IN THE MATTER of Proposed Plan Change 26 to the Operative Waipā
District Plan

REBUTTAL STATEMENT OF EVIDENCE OF CAROLYN JOY HILL

Dated 19 April 2023

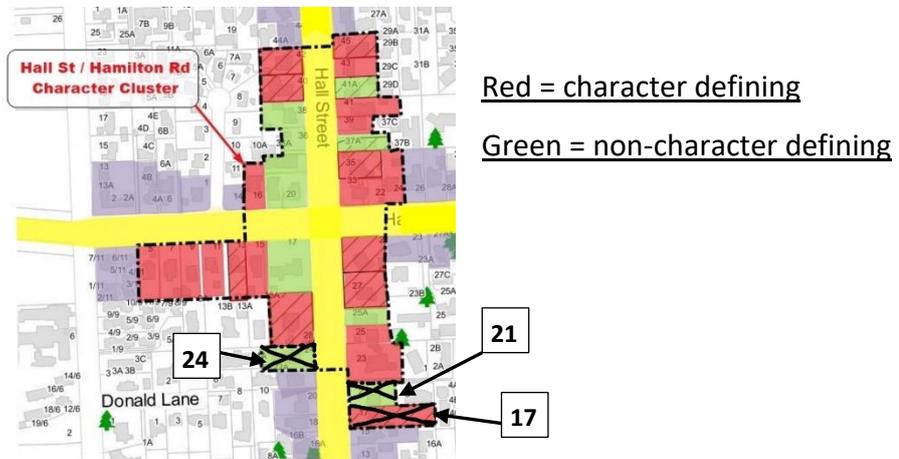
c) **Retain** Restricted Discretionary Activity 2A.4.1.3(d) as drafted in the Section 42A report Appendix A, i.e.

Character clusters sites (32.3) - Construction of new buildings, relocated buildings and demolition or removal or alterations or additions to existing buildings, except where permitted by 2A.4.1.1(q) and (r). (32.3)
